**Economic and Social Council**Distr.: General
22 January 2018

Economic Commission for Europe**Inland Transport Committee****World Forum for Harmonization of Vehicle Regulations****Working Party on General Safety Provisions****114th session**

UN Regulation No. 73 (Lateral protection devices)**Proposal for the 02 series of amendments to UN Regulation No. 73
(Lateral Protection Devices)****Submitted by the expert from France***

Figure 1

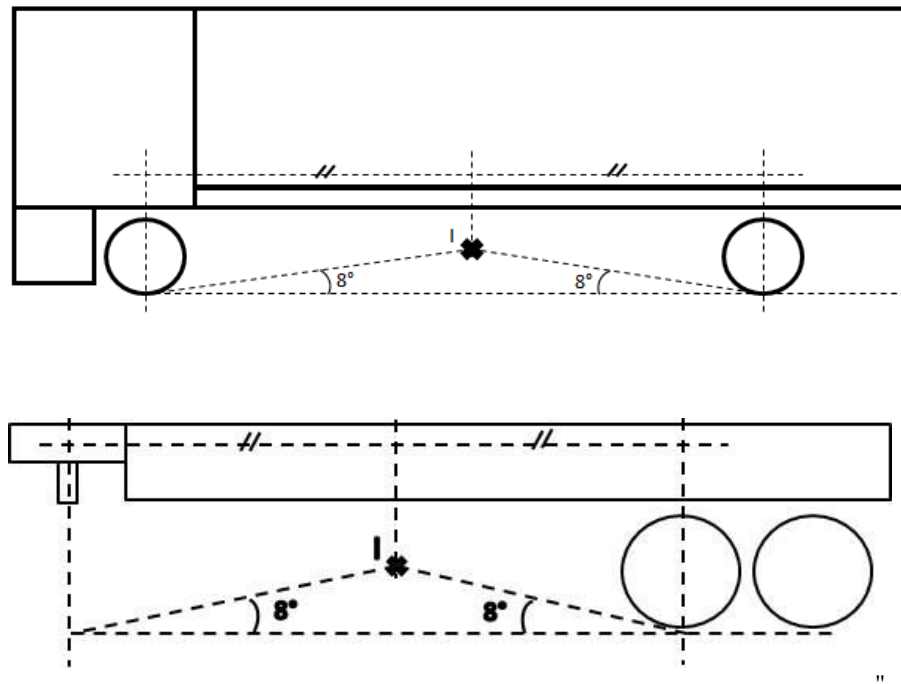
- "12.8. The lower edge of LPD shall **be defined as follows:**
- (a) **If $I \leq 350$ mm then the ground clearance can be 350 mm maximum;**
 - (b) **If $350\text{mm} < I \leq 450\text{mm}$ then the ground clearance is I;**
 - (c) **If $450\text{mm} < I$ then the ground clearance is 450 mm maximum;**
- with intersection point I defined as mentioned in Figure 1.**

Figure 2

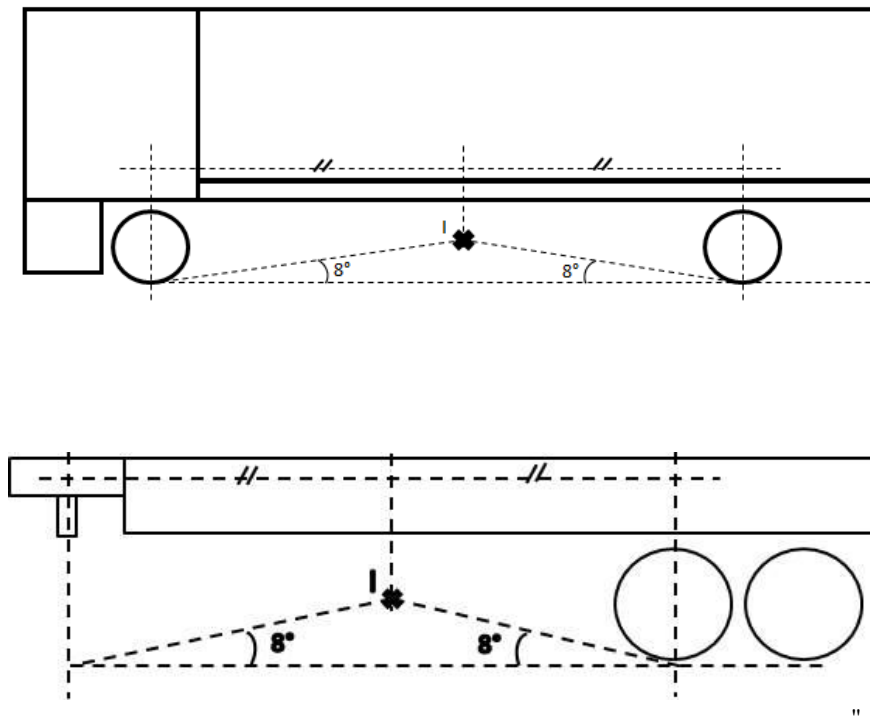
"15.6. The lower edge of LPD shall **be defined as follows:**

- (a) **If $I \leq 350$ mm then the ground clearance can be 350 mm maximum;**
- (b) **If $350 \text{ mm} < I \leq 450$ mm then the ground clearance is I;**
- (c) **If $450 \text{ mm} < I$ then the ground clearance is 450 mm maximum;**

with intersection point I defined as mentioned in Figure 2.
